VSP-33
December 18, 1981

VENDOR SERVICE PUBLICATION

To: All Piper Distributors and CORPAC's
Subject: Bendix Service Bulletins 611, 616, 617, 619

Figure 1. Location of Drain Holes

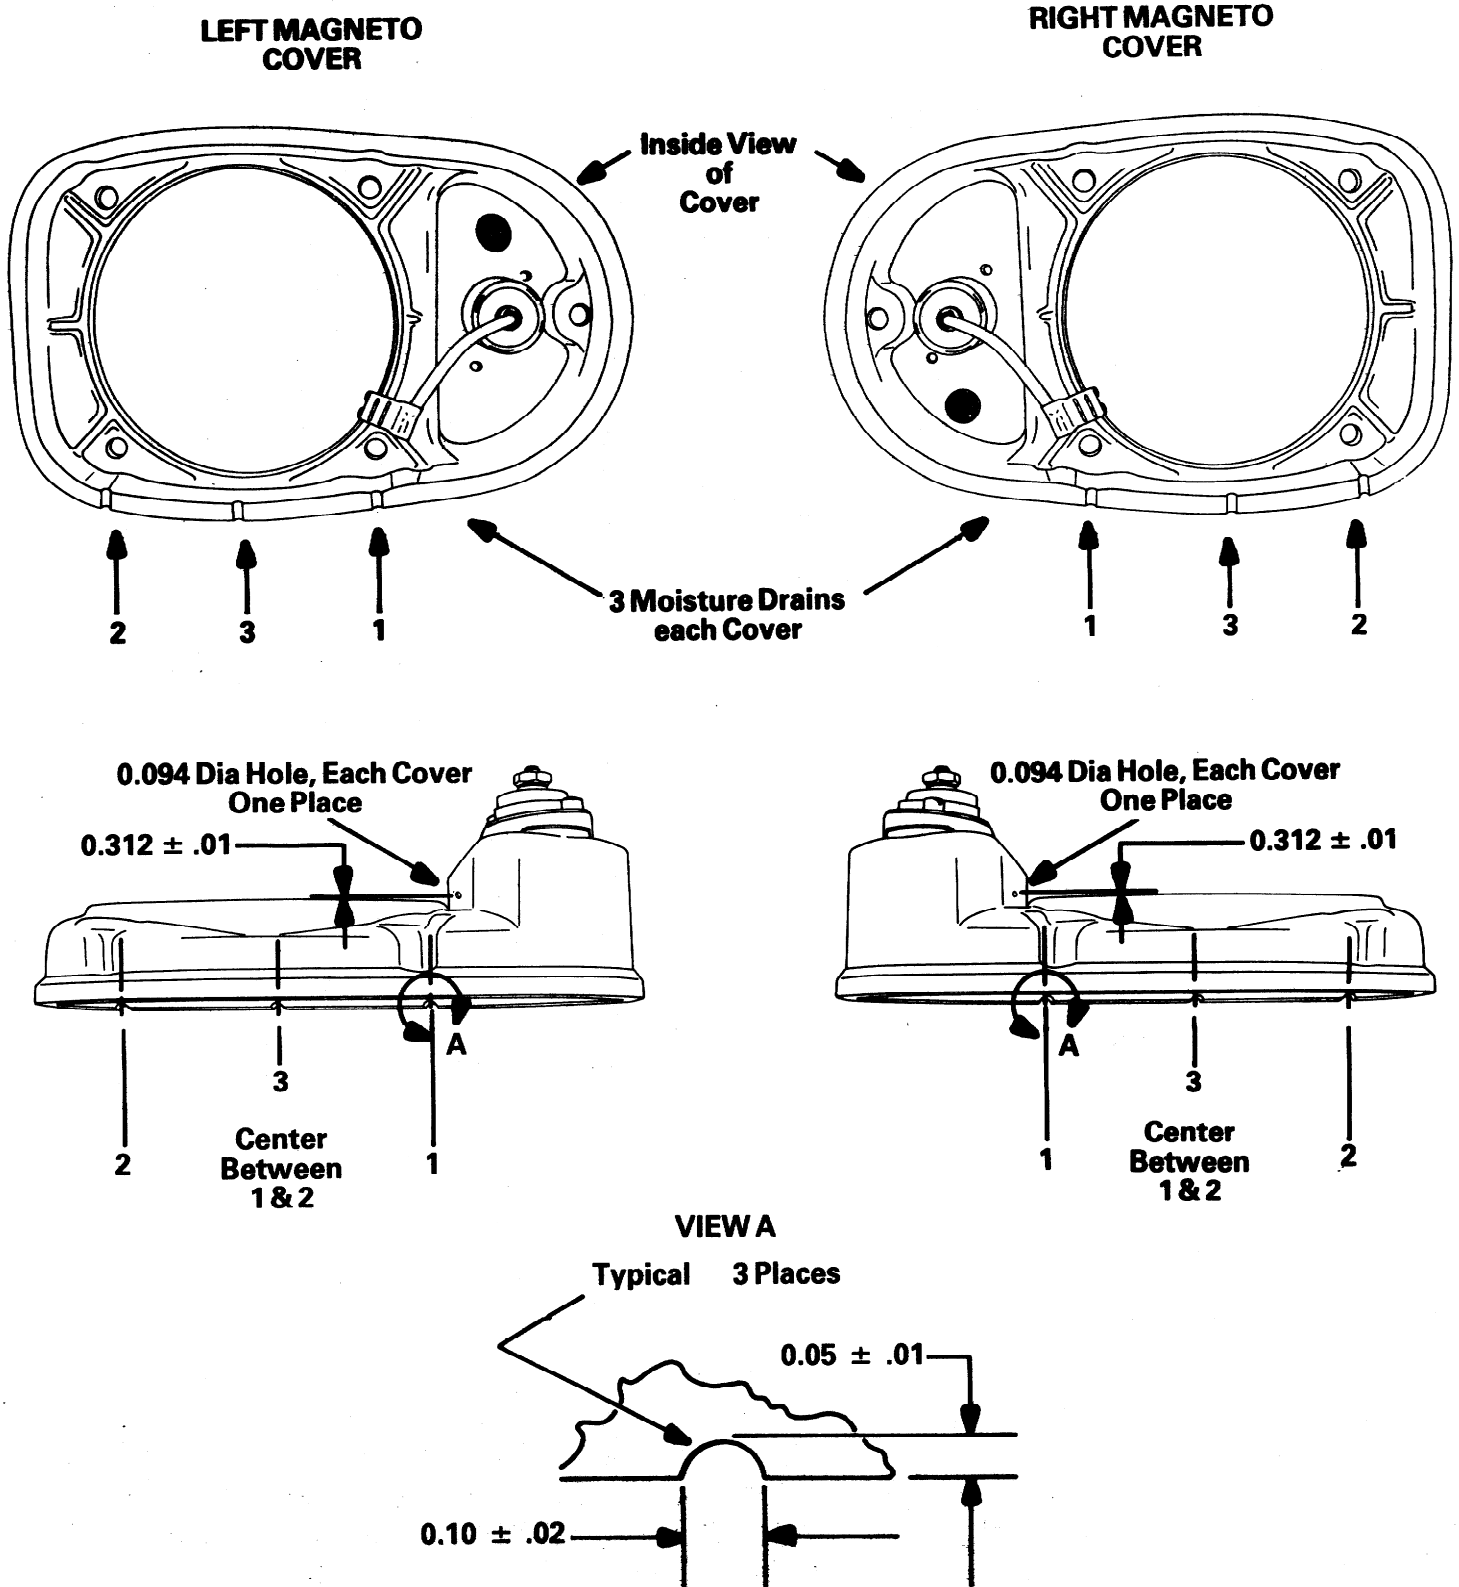
1. Remove the magneto cover by removing the ignition harness adapter plate from each magneto and then removing the magneto cover securing screw. Pull the magneto cover away from the magneto and carefully pull the capacitor, and retard lead, if used, from the breaker flag terminal(s).
2. Using Figure 1 as a guide, lay out the positions for the moisture drains. Positions 1 and 2 are in line with the stud holes in the cover and position 3 is centered between 1 and 2. Using a small round file, create the three hemispherical recesses as detailed in view A, figure 1.

The moisture drains must be on the lower side of each cover when it is reinstalled on its related magneto assembly on the engine.

3. Lay out the position for drilling a 0.094 in. \pm 0.005 in. hole in the center of the ledge area of the covers and drill one hole in each cover using a 3/32" or No. 42 drill, as shown in Figure 1.

Do not allow the drill to penetrate through the cover and hit the housing of the capacitor which is directly in line with the hole being drilled. Mask drill bit for maximum allowable depth (1/4 in.).

Figure 1. Exploded View

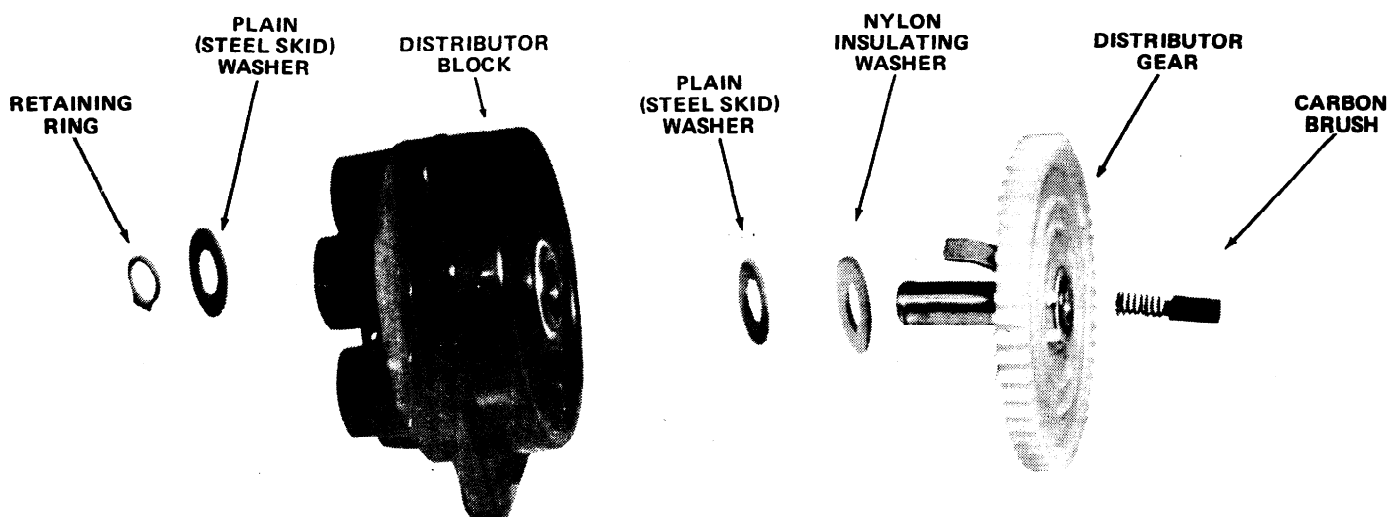
The 10-357584 and 10-357586 Insulated Distributor Gear Kits for S-20 and S-200 Series Magnetos are being provided as a standardization change for Bendix magnetos. With the introduction of these kits, all new Bendix aircraft magnetos delivered from the factory will be provided with insulated distributor gears. The insulated gear kits include all parts (except distributor block) as identified in figure 1.

Assembly sequence of the gear kit to distributor block is shown in the exploded view of figure 1.

Figure 1. Location of "x" on Identification Plate

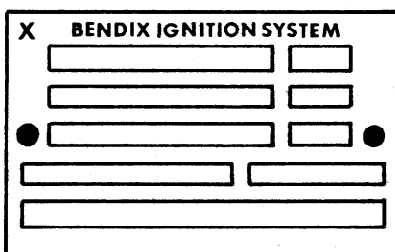
All D-2000/2200 series magnetos below serial number 35480 (red label magnetos) and below serial number 8122106 (blue label magnetos) unless identified with an "x" in the upper left corner of the identification plate before the word "Bendix" (see figure 1). The "x" on the identification plate indicates previous compliance.

6. If new serviceable gears, identified with the "z", the "x" and "o", or the "L" are installed in the magneto, identify the magneto by stamping the letter "x" in the upper left corner of the identification plate, before the word "Bendix" (see figure 1).

Figure 2. Location of Identification Mark(s)
on Distributor Gear

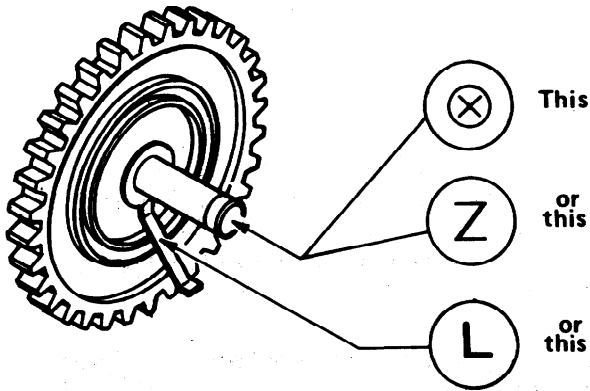
hours or at the next regularly scheduled inspection, whichever occurs first, and reinspected every 100 operating hours until the magneto has 500 operating hours. If the gears fail the inspection they must be replaced immediately with new, serviceable gears; if they pass each inspection they may remain in service until magneto overhaul, at which time they must be replaced with new, serviceable gears. At owner's option, gears that pass inspection may be replaced at any time during the compliance period with new, serviceable gears as identified in this paragraph and figure 2. Serviceable gears are identified by the presence of the letter "z" or the letters "x" and "o" appearing together, laser etched on the retaining ring end of the gear axle, or the letter "L" stamped on the electrode (see figure 2).

1. Remove cover from magneto and inspect the retaining ring end of the distributor gear axles for the letter "z" or the letters "x" and "o". (The letter "x" may or may not be circled by the letter "o".) If the letter "z" or the letters "x" and "o" together are laser etched on the end of the axles, the gears are serviceable and the cover can be reinstalled. Identify the magneto per

Figure 3. Checking for Loose Electrode

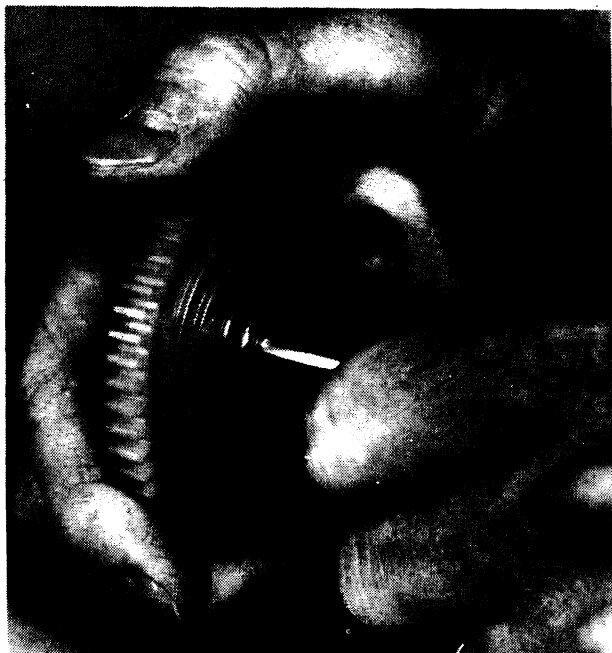
5. If the gear is the uninsulated type (no nylon washer) inspect the gear for a loose electrode. Grasp the gear firmly in one hand and alternately exert clockwise and counterclockwise force against the electrode with maximum hand pressure. This should be done in a manner that would attempt to pivot the electrode around the axle (see figure 3). If any movement is detected between the electrode and the gear, the gear must be discarded and replaced with a new, serviceable gear.

Figure 1. Location of "x" on Identification Plate

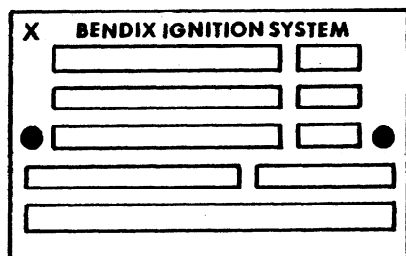
All D-3000/3200 Series (blue) Magnetos with Serial Numbers 100 through 1968 not identified by the letter "x" in the upper left corner of the identification plate (see figure 1). The "x" on the identification plate indicates previous compliance.

7. After the magneto has been reassembled with new serviceable gears, identify the magneto by stamping the letter "x" in the upper left corner of the identification plate, before the word "Bendix" (see figure 1).

Figure 2. Location of Identification Mark(s)
on Distributor Gear

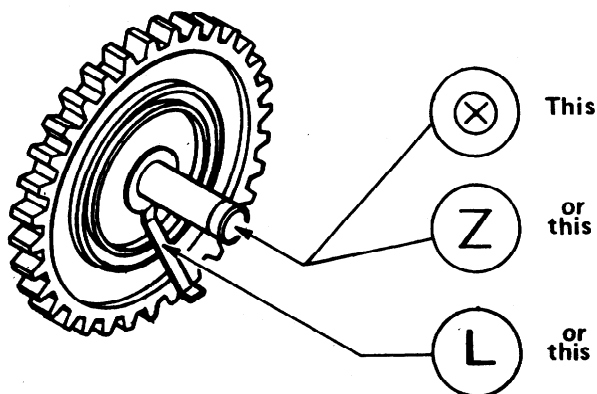
All distributor gear kits P/N 10-682014 and P/N 10-682016 which contain gears that are not identified by the presence of the letter "z" or the letters "x" and "o" together, laser etched on the retaining ring end of the gear axle, or the letter "L" stamped on the electrode (see figure 2).

5. Reassemble the distributor block with new serviceable gears. Serviceable gears are identified by the presence of the letter "z" or the letters "x" and "o" together, laser etched on the retaining ring end of the gear axle, or the letter "L" stamped on the electrode (see figure 2).
